P&Z CASE # SP2019-001 P&Z DATE _____ CC DATE _____

RE: SITE PLAN (SP2018-001), SUP for 7-11

Project Number: SP2018-001
Project Name: 7-11
Project Type: SITE PLAN
Applicant Name: VERDAD REAL ESTATE
Owner Name: PATMAN, CONNOR W JR
Project Description:

City of Rockwall Project Plan Review History

SITE PLAN

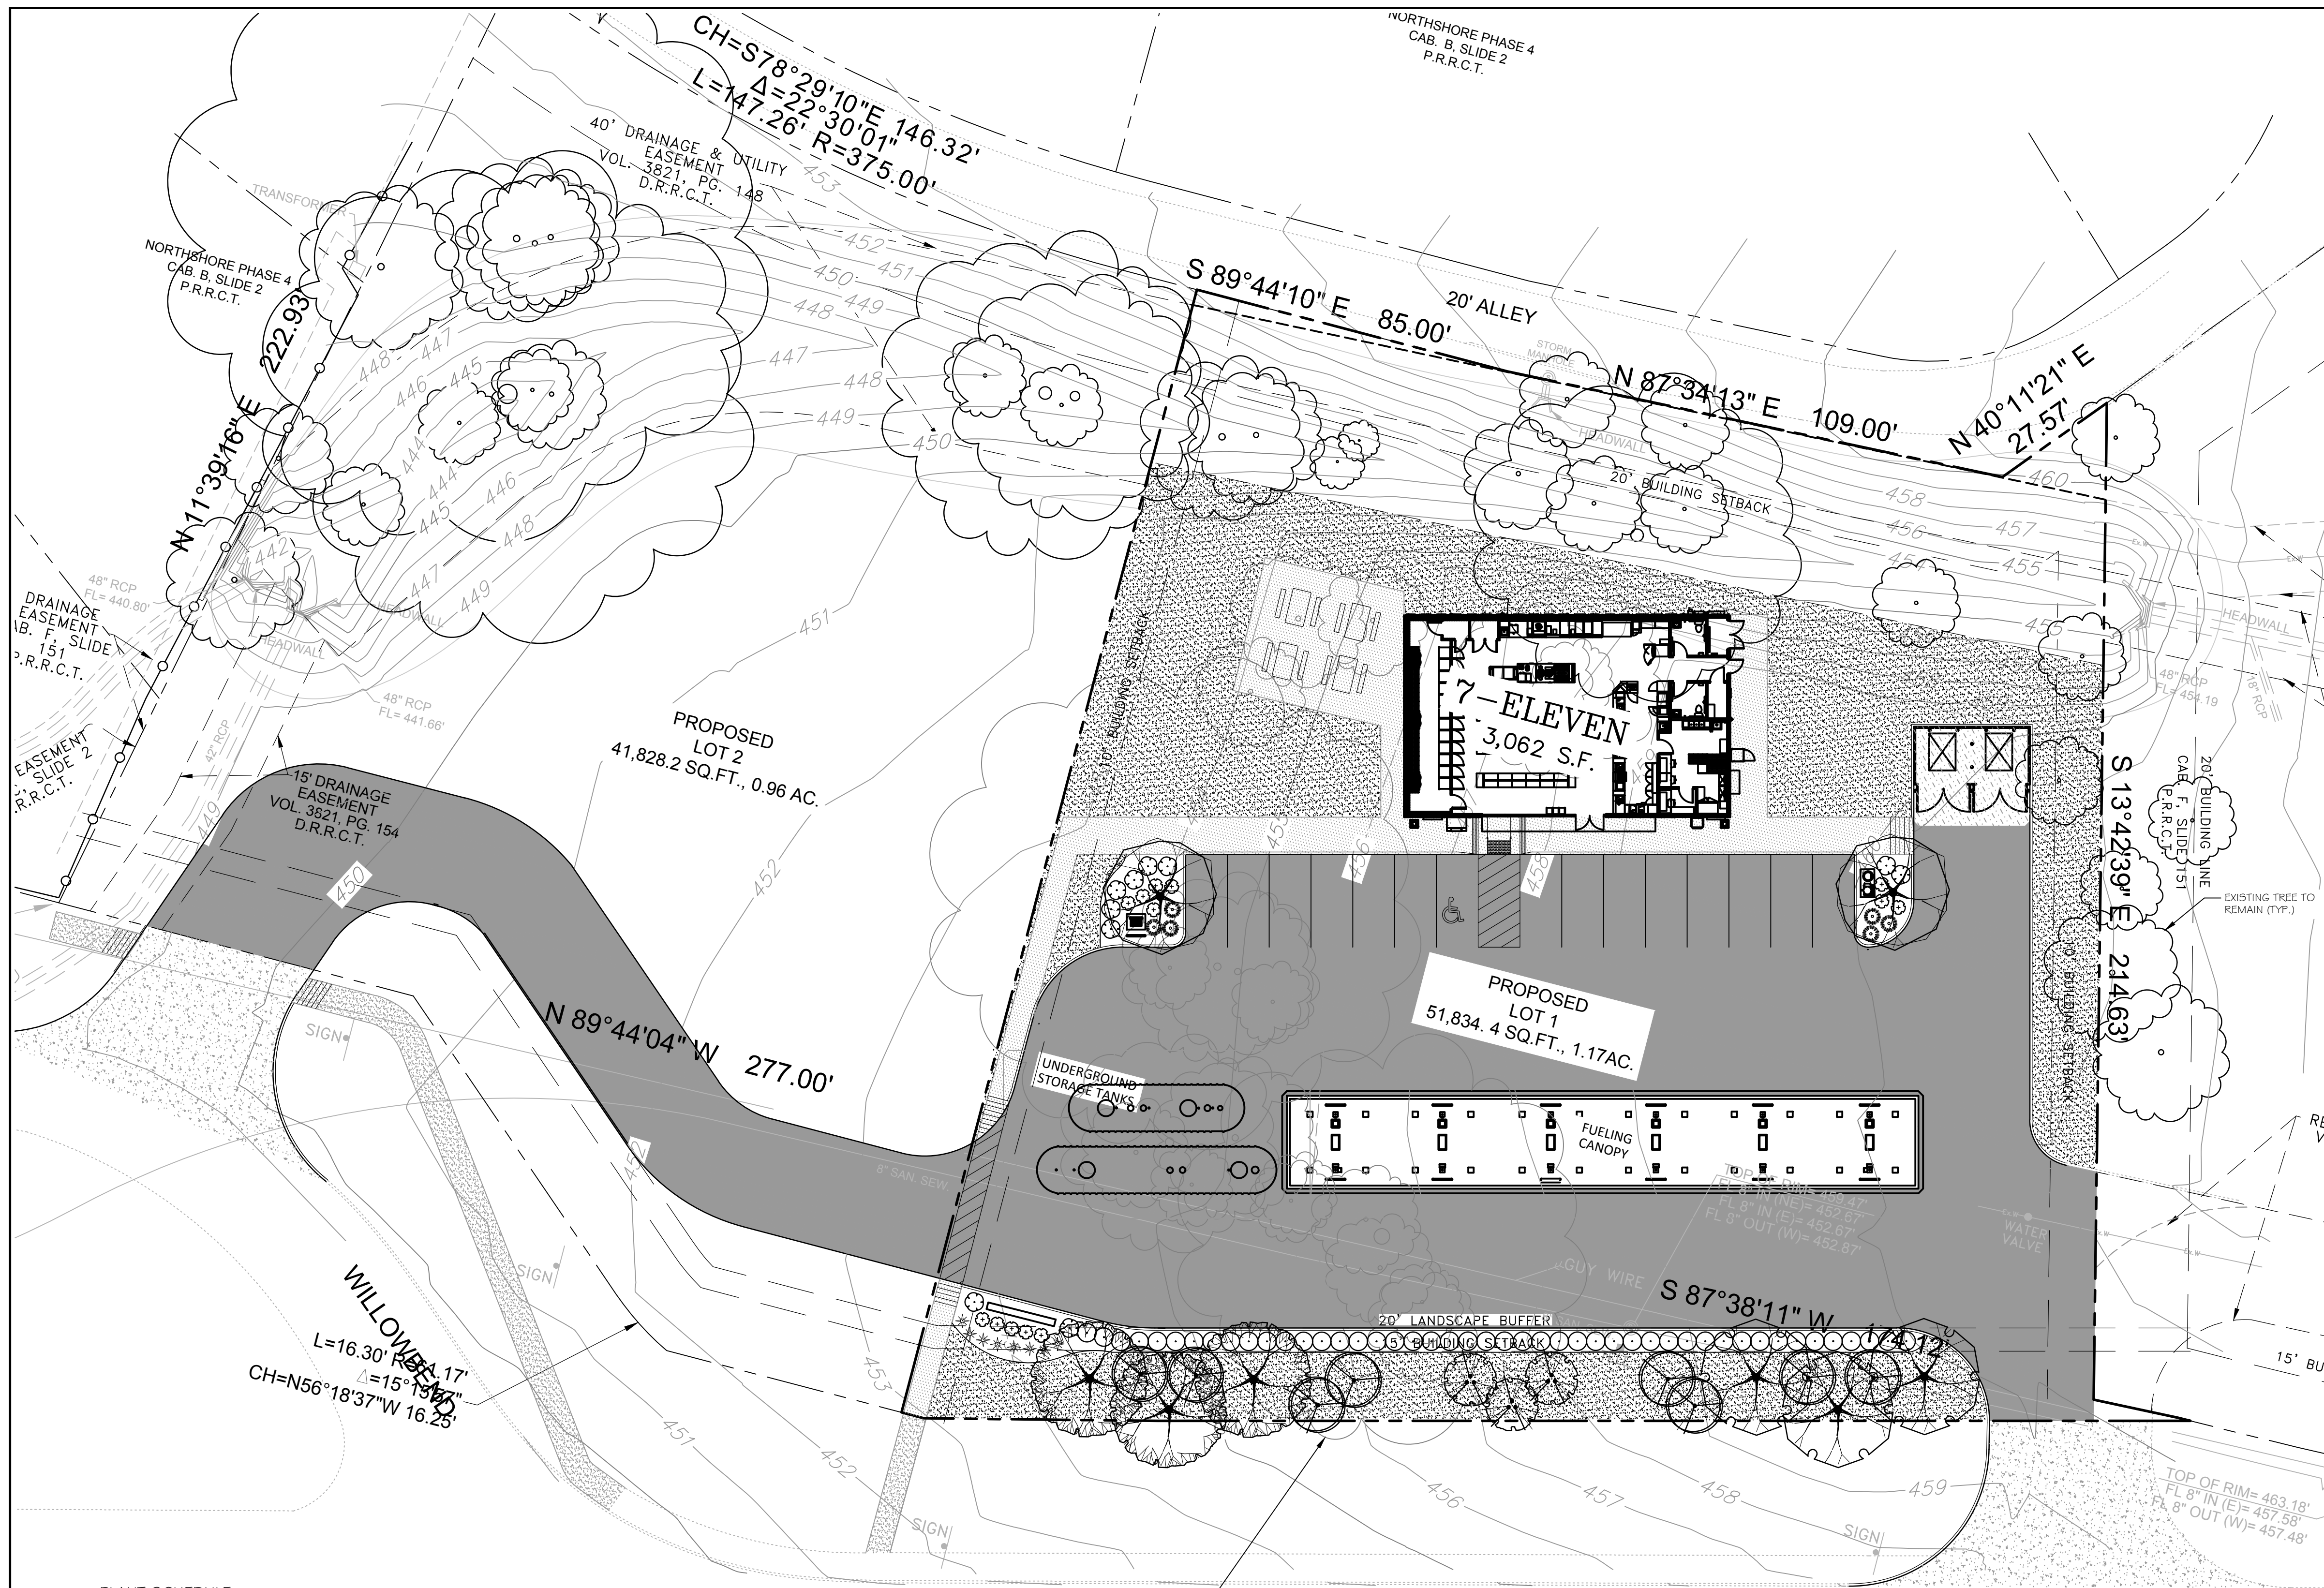
M.11						Site Plan. Please provide elevation of dumpster enclosure. Note that in an overlay district, the enclosure is 8-feet high.
M.12						Site Plan. Please only show the footprint of building. Do not include the floorplan.
M.13						Site Plan. Please show centerline of SH-66 on all plans
M.14						Landscape Plan. Please provide the same Site Data Table as provided on the Site Plan.
M.15						Landscape Plan. Please only show building footprint as mention in M.13.
M.16						Landscape Plan. Please move the fuel vent pipes to they are screen by the landscaping (move the pipes backward and move some of the landscape screening in front.
M.17						Treescape Plan. Please show tree mitigation table (i.e. provide a table with the each tree listed, total caliper inches of the tree, protected or not, saved or removed, if it is being mitigate for).
M.18						Treescape Plan. Please only show building footprint without floorplan.

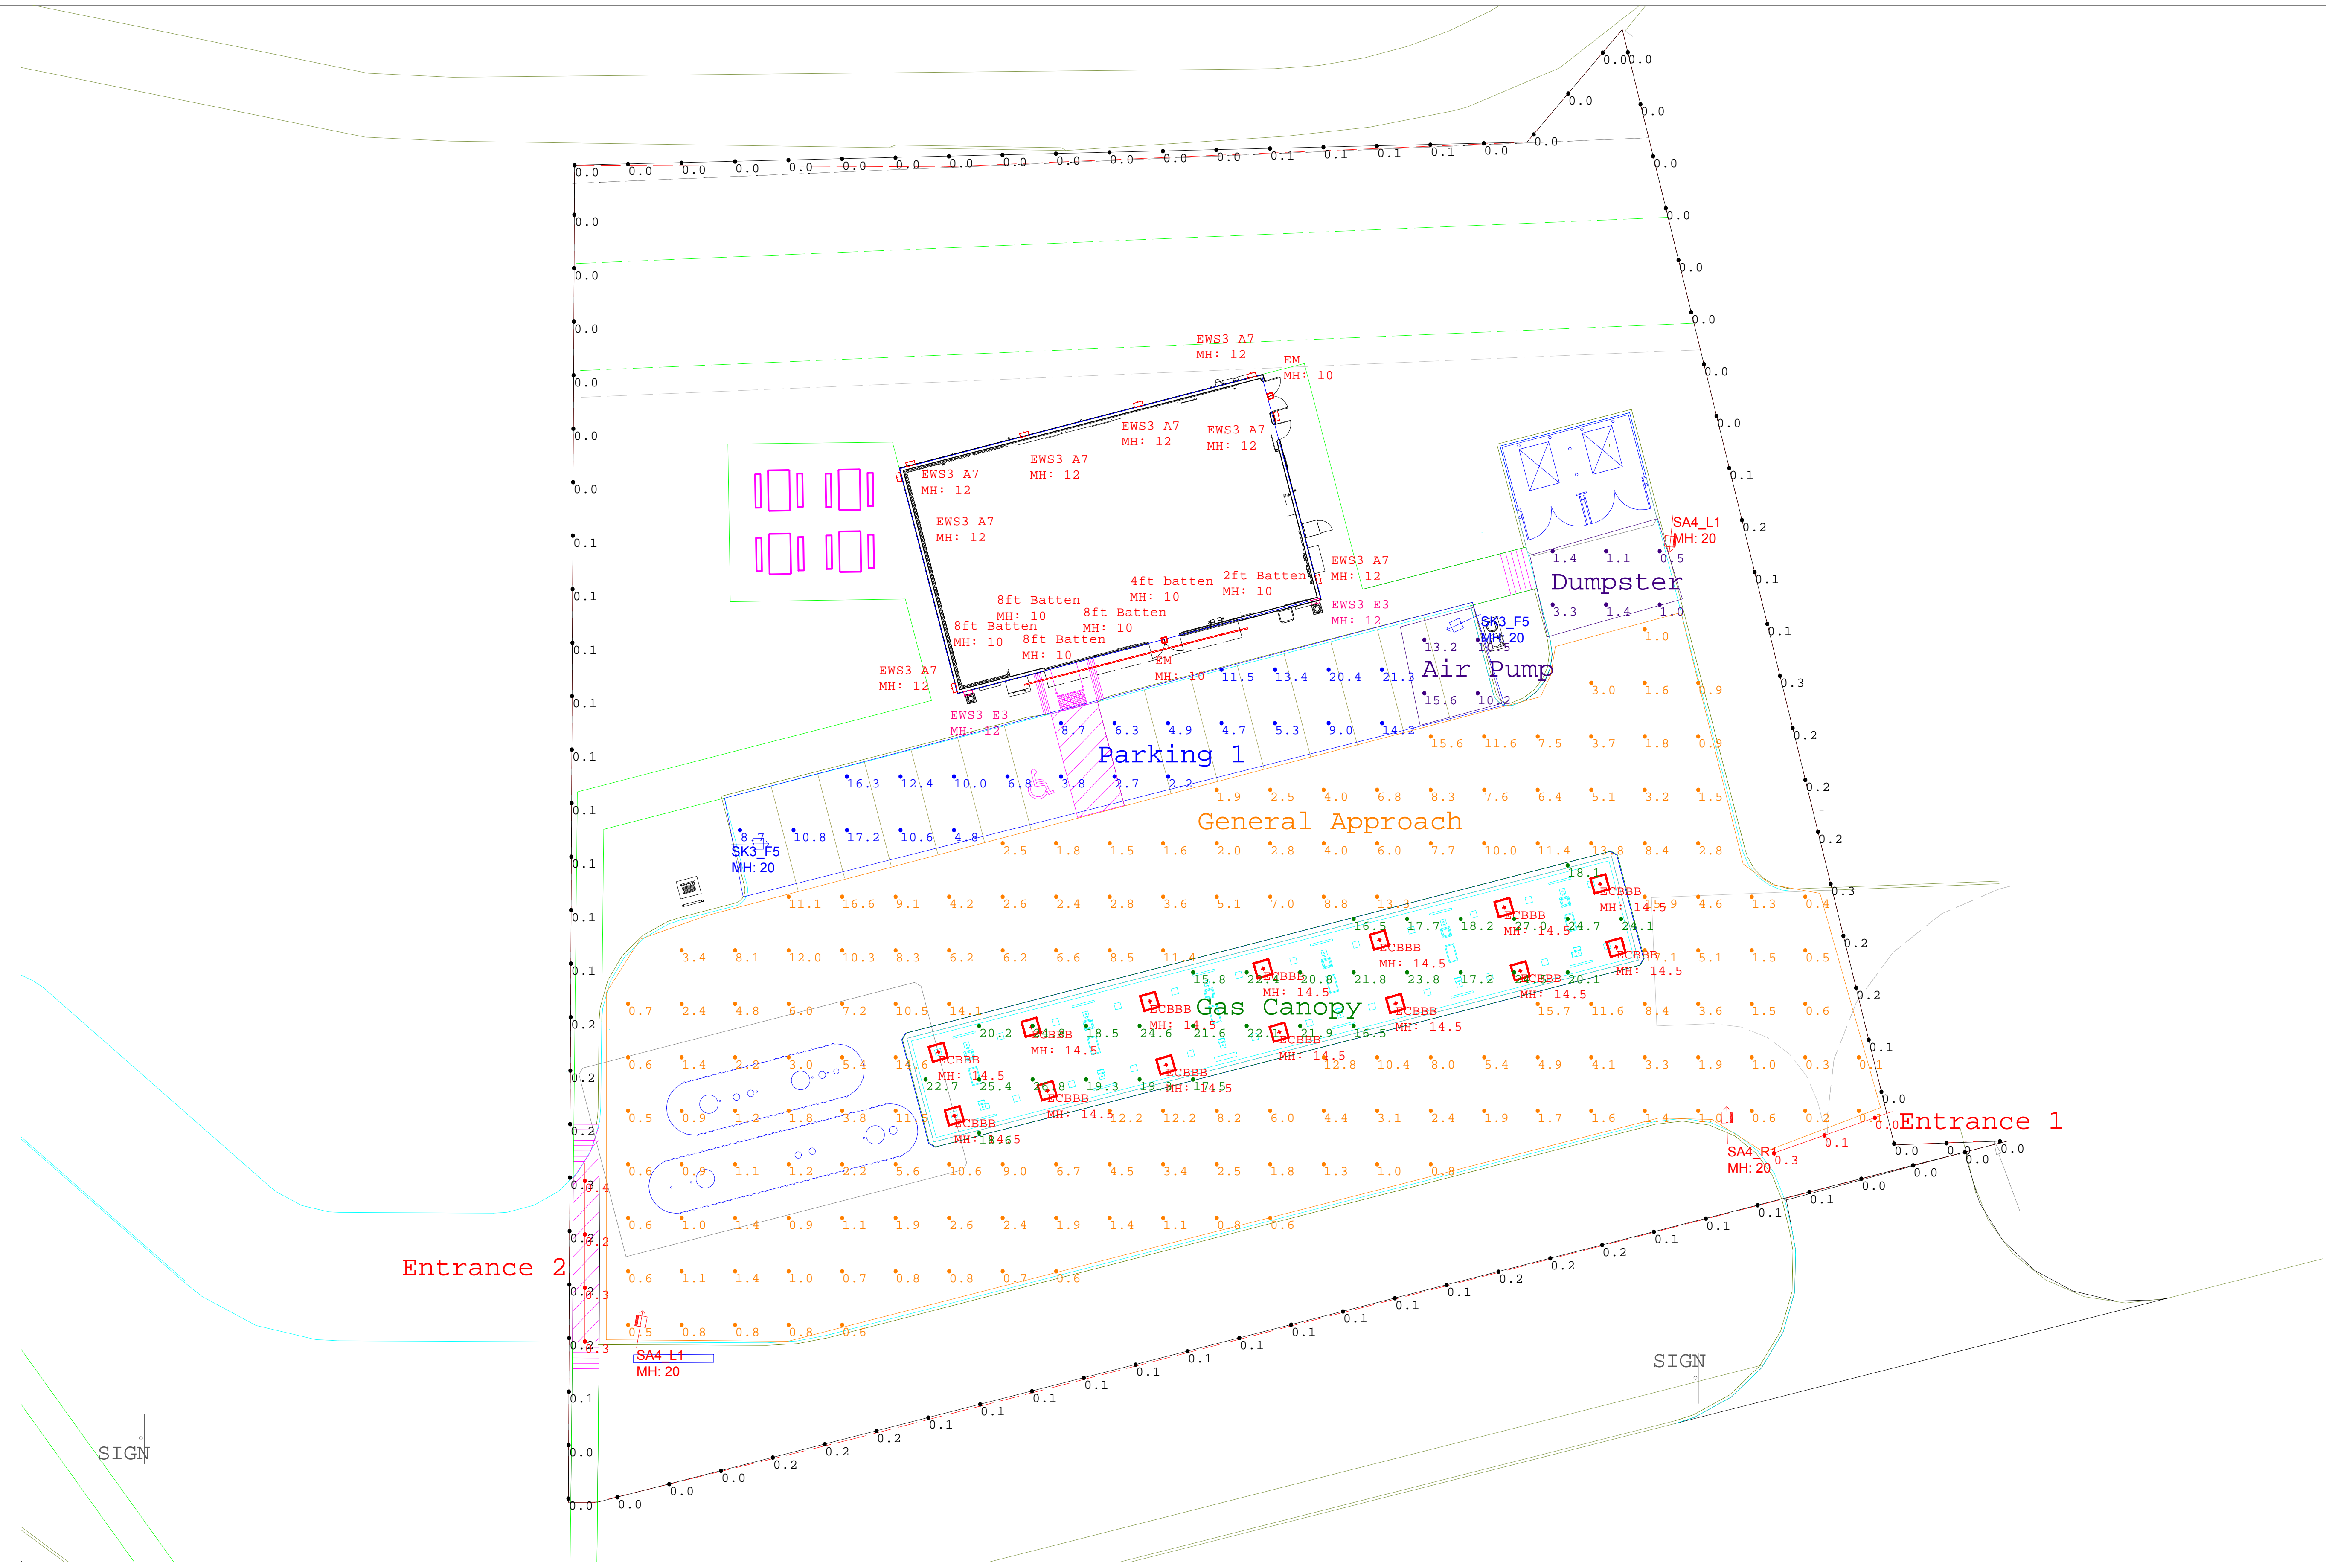
M.19						Treescape Plan. Please show same data table as site plan
M.20						Photometric Plan. Please indicate property line on photometric plan.
M.21						Building Elevations. Please note that the overlay district requires 8-foot dumpster enclosure.
M.22						Building Elevations. Please note that as shown, the building will require a variance to 4 sided architecture and 20% natural stone requirements. There is no horizontal articulation and you are proposing cultured stoned.
M.23						Building Elevations. Please note that the outside storage (i.e. ice machine and Redbox machine) will need to be under a covered walkway and shown on the site plan.
M.24						Building Elevations. Please indicate the elevation that faces the street.
M.25						Building Elevations. Please provide dumpster enclosure elevation.
I.26						The Architectural Review Board (ARB) meeting for this case will be held on January 30, 2018 at 5:00 p.m.
